MONTICELLO NUCLEAR GENERATING PLANT
Docket No. 50-263 License No. DPR-22

License Amendment Request Dated March 21, 1978

REQUEST FOR AMENDMENT TO
OPERATING LICENSE NO. DPR-22

PROPOSED CHANGES TO TECHNICAL SPECIFICATIONS

Figure 3.11.1-A

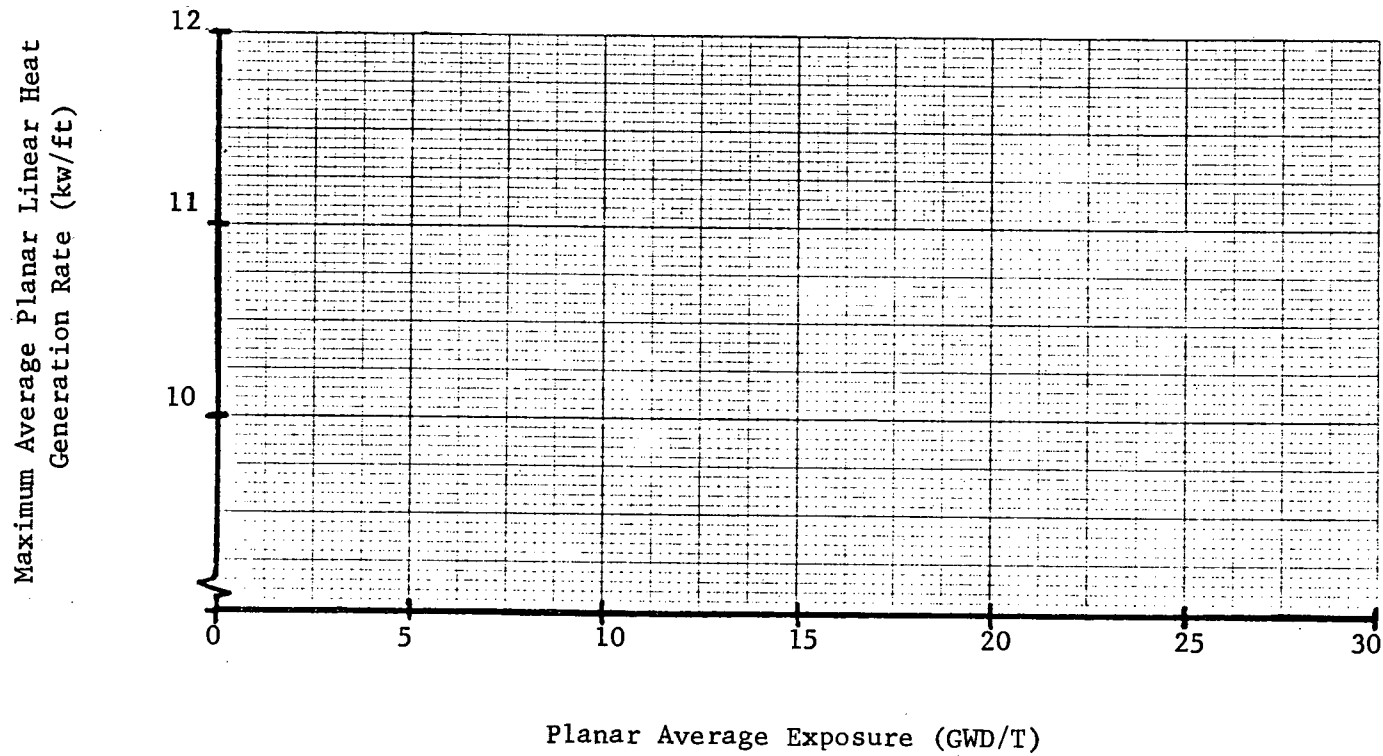
Pages 189H, 189I, 189Ia, 189J and 189K. Page 189Ia is a newly created page. All pages listed here are intended for the documentation of MAPLHGR limits as determined using the partial drill ECCS model discussed in the Safety Evaluation. The calculational results will be provided at a later date.

Calculated Results to
be provided at a later
date.

Figure 3.11.1-B

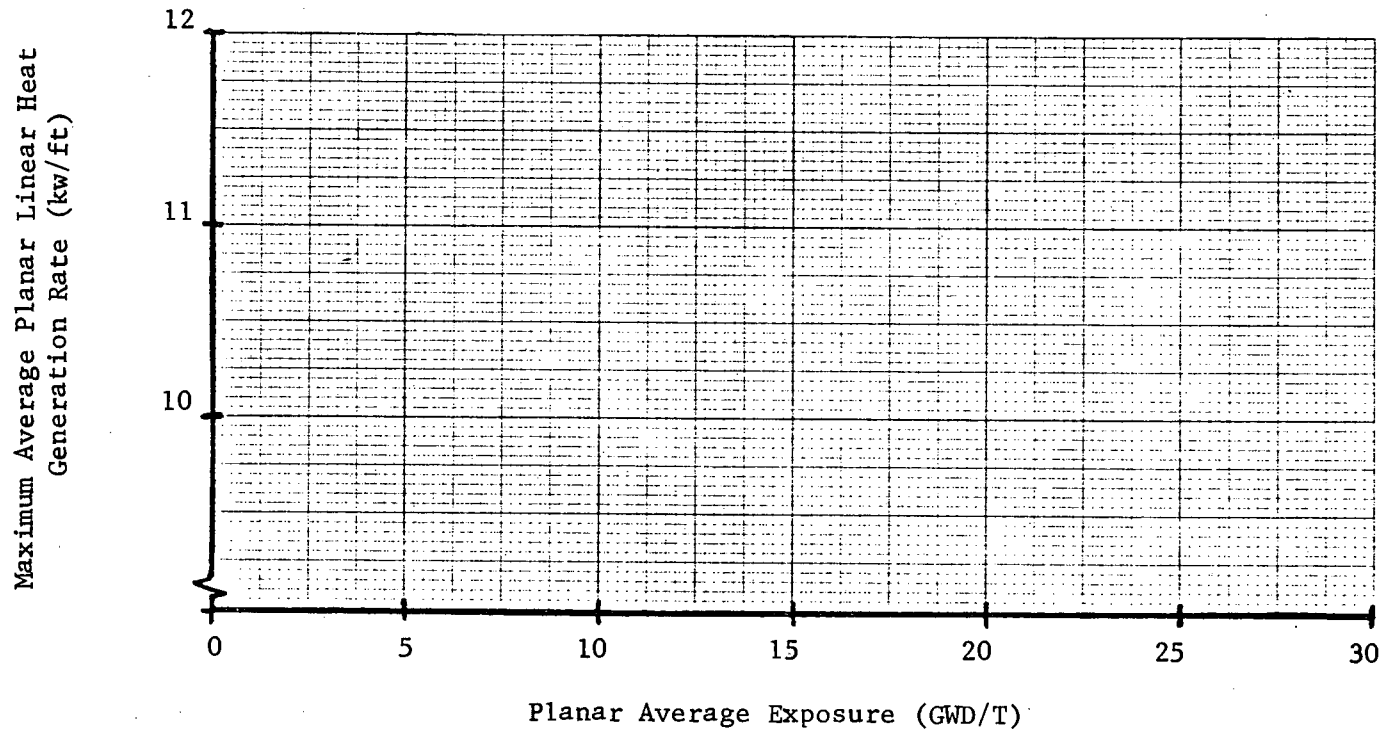
Page vii. Modify the title of Figure 3.11.1-B and add a new Figure 3.11.1-Ba as shown in Exhibit B.

The Technical Specifications presently include a MAPLHGR limit for 7D230 fuel, a fuel type that is not expected to be used at Monticello in the future. MAPLHGR limits are therefore eliminated for 7D230 fuel. That page is replaced with limits for a new fuel type, 8DR 264. Limits for the other new fuel type, 8DR 282, are on a newly created page.

Calculated Results to
be provided at a later
date
